Below are comments for four different agenda items of the 1-30-2024 Transportation Commission meeting.

81744 Vision Zero Annual Report

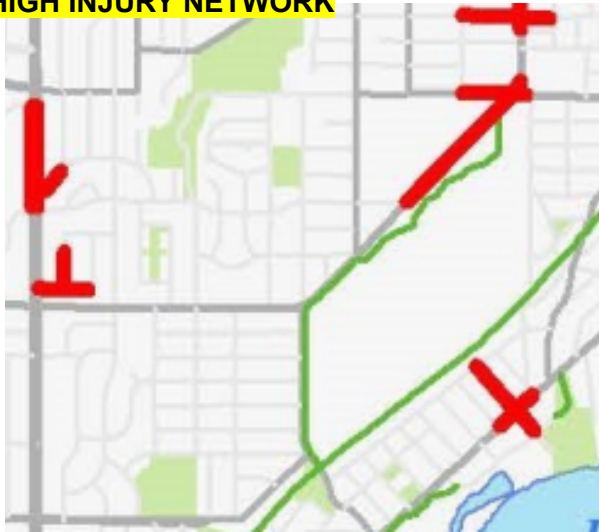
I support the Master Plan, but am disappointed it excludes the bike/ped area along Monona Terrace. Early in the competition, design firms offered these exciting renderings of what could be done in that area:

It would be nice if the master plan explained why this important area was excluded from consideration.

HIGH INJURY NETWORK

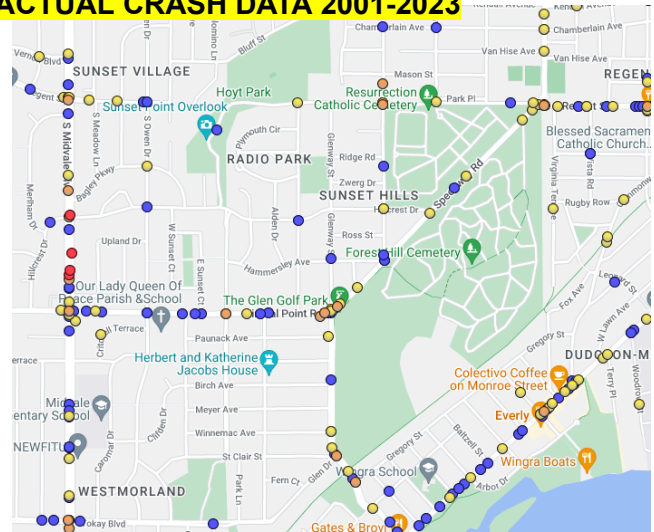
First, High Injury Network methodology used for Vision Zero doesn't seem close to actual injury crash data. E.g., Here is a spot comparison of near-west Madison.

Mineral Point Rd, Glenway, Monroe St, and Regent east of West High all have many real-world crashes with injuries, yet they are not flagged as part of the High Injury Network. The [2014 Near Westside Neighborhoods and University Avenue Corridor Transportation Study](#) (p. 45) indicated that the Glenway / Speedway intersection was the crashiest intersection on the near west side. Meanwhile, streets like Falles Ct are flagged for the High Injury Network even though it's never had a crash and probably doesn't see more than 10 cars an hour.
